## McClellan Air Force Base

**Draft Final Copy  
Interim Record of Decision  
Davis Global Communications Site**

SUBJECT: Draft Final Copy, Interim Record of Decision (IROD), Davis Global Communications Site

**FIGURE 2-1**  
**SITE MAP**  
**DAVIS GLOBAL COMMUNICATIONS SITE**  
**McCLELLAN AIR FORCE BASE**  
**YOLO COUNTY, CALIFORNIA**

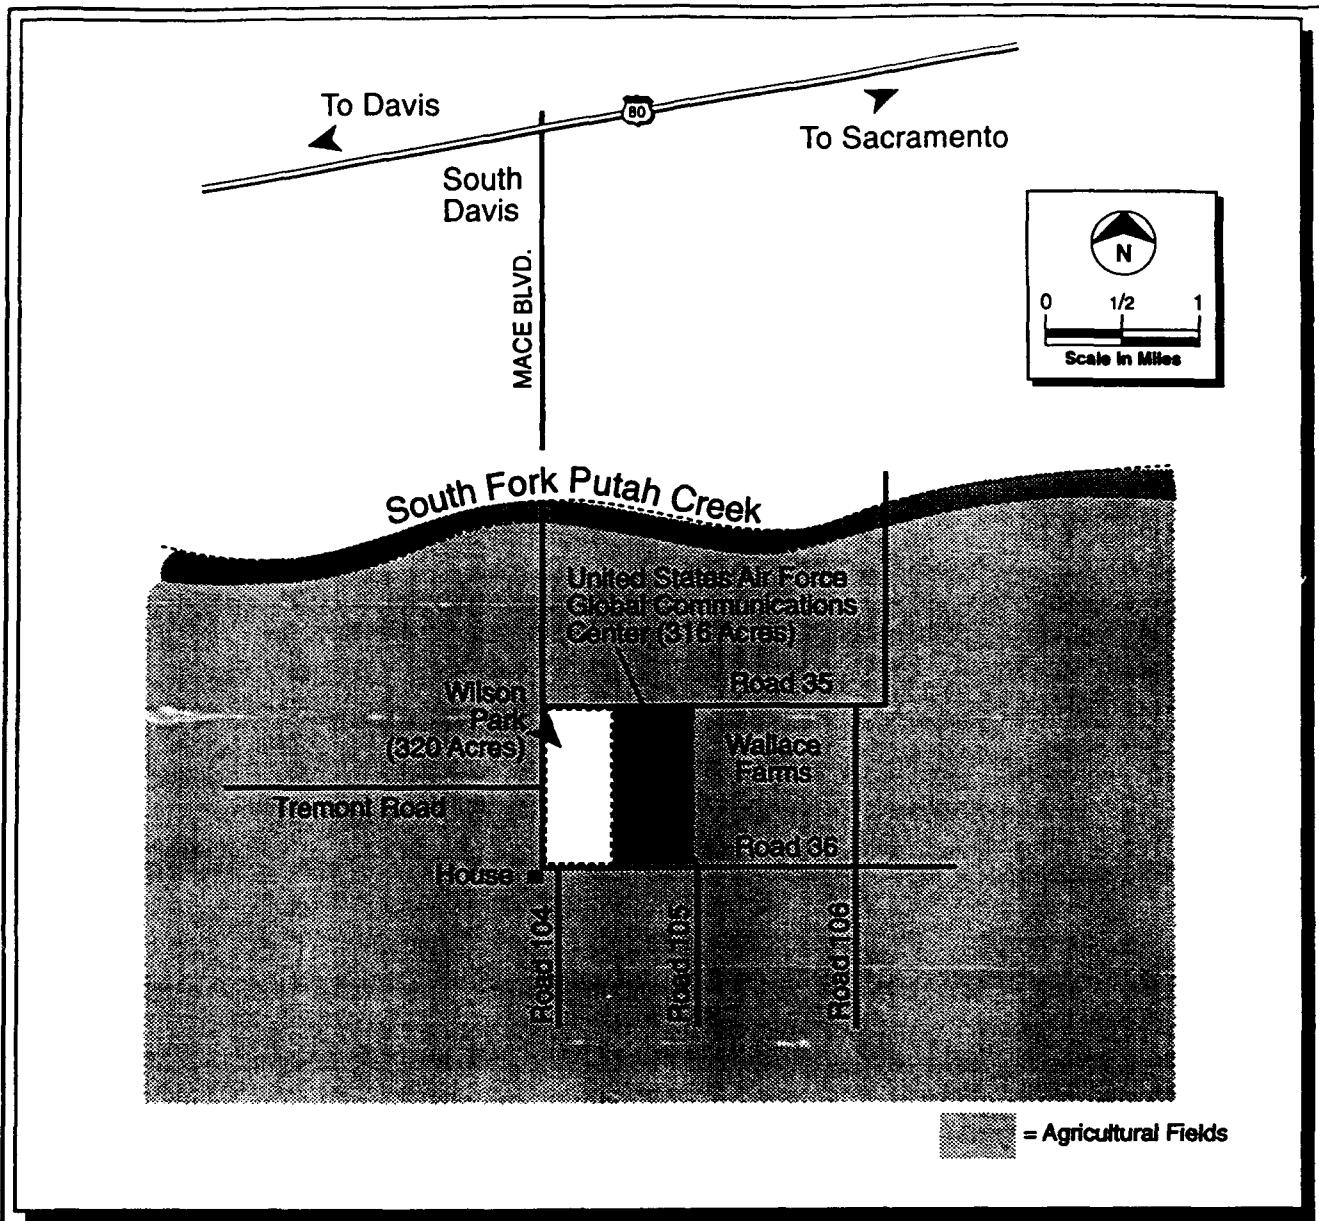
1. Fig. 2-1. The site map should show proximity to the "local" community, not to a golf course.

Noted change made to Figure 2-1.

**FIGURE 2-7**  
**VERTICAL GRADIENTS**  
**AT WELL CLUSTER MW3**  
 DAVIS GLOBAL COMMUNICATIONS SITE  
 McCLELLAN AIR FORCE BASE  
 YOLO COUNTY, CALIFORNIA

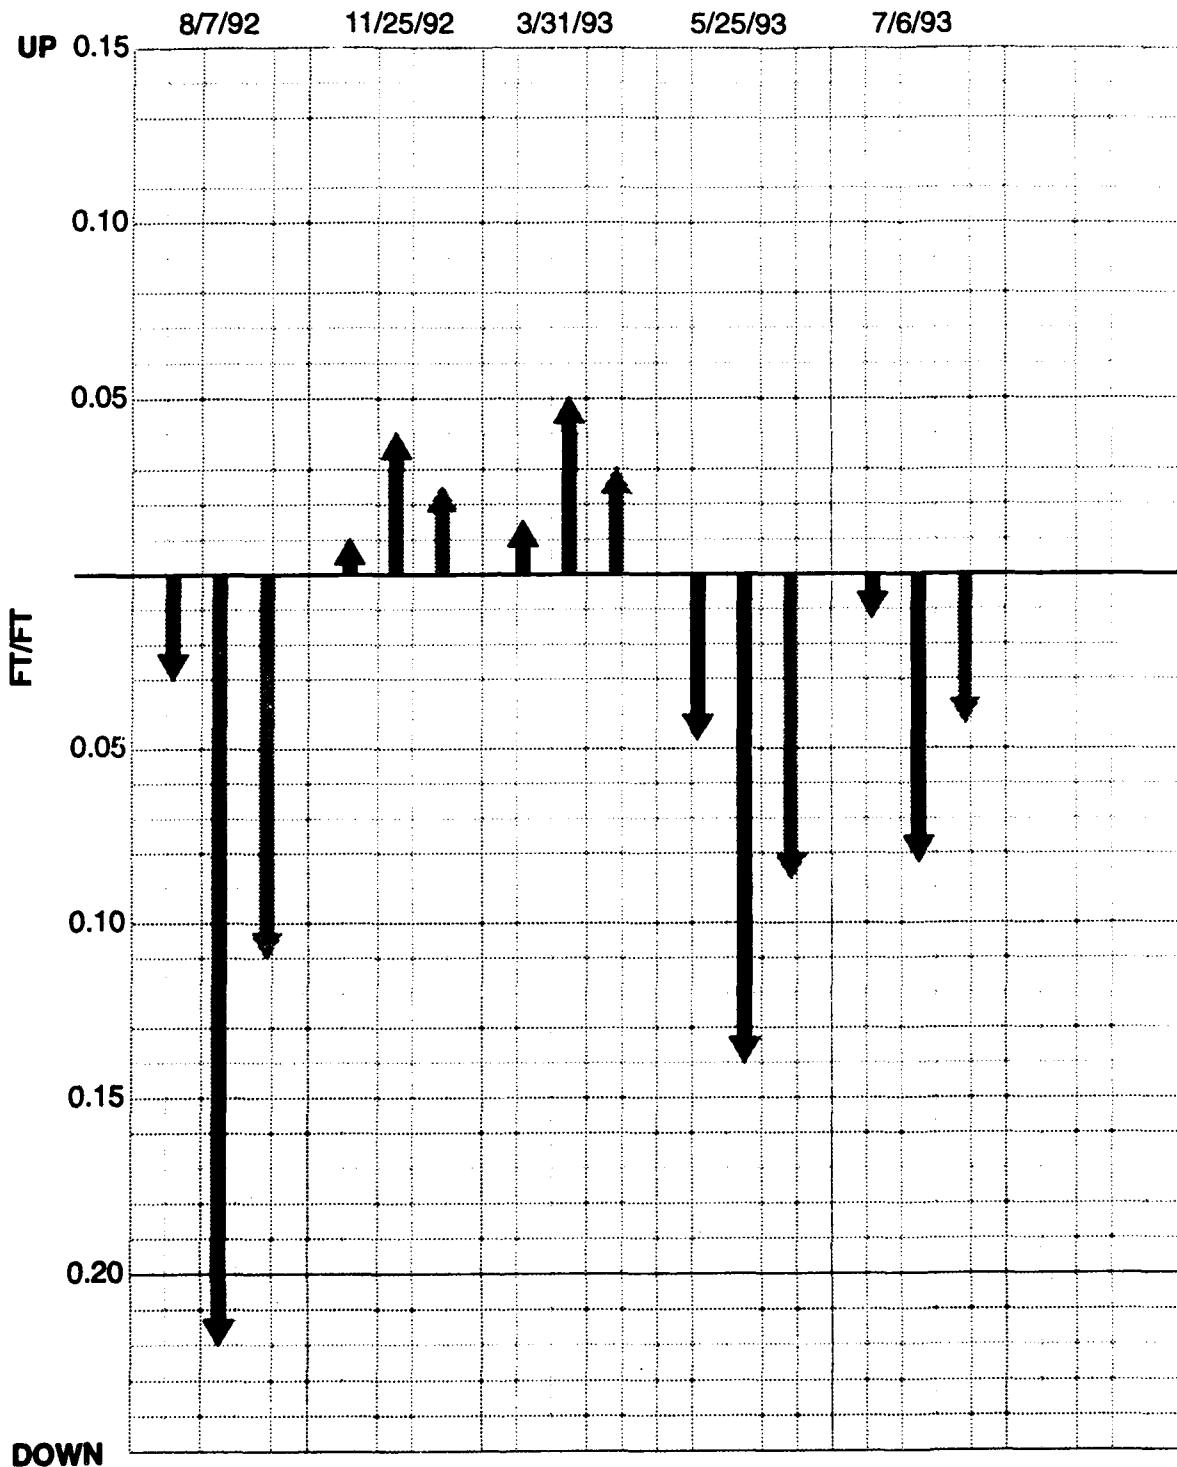
10. Pgph 3. Vertical gradients for the B zone should also be discussed and included in Figure 2-6.

Groundwater levels for the B zone are nearly identical with those from the C zone. Therefore, vertical gradients between the B zone and lower zones are the same as those shown in Figure 2-7 for the C zone and lower zones.
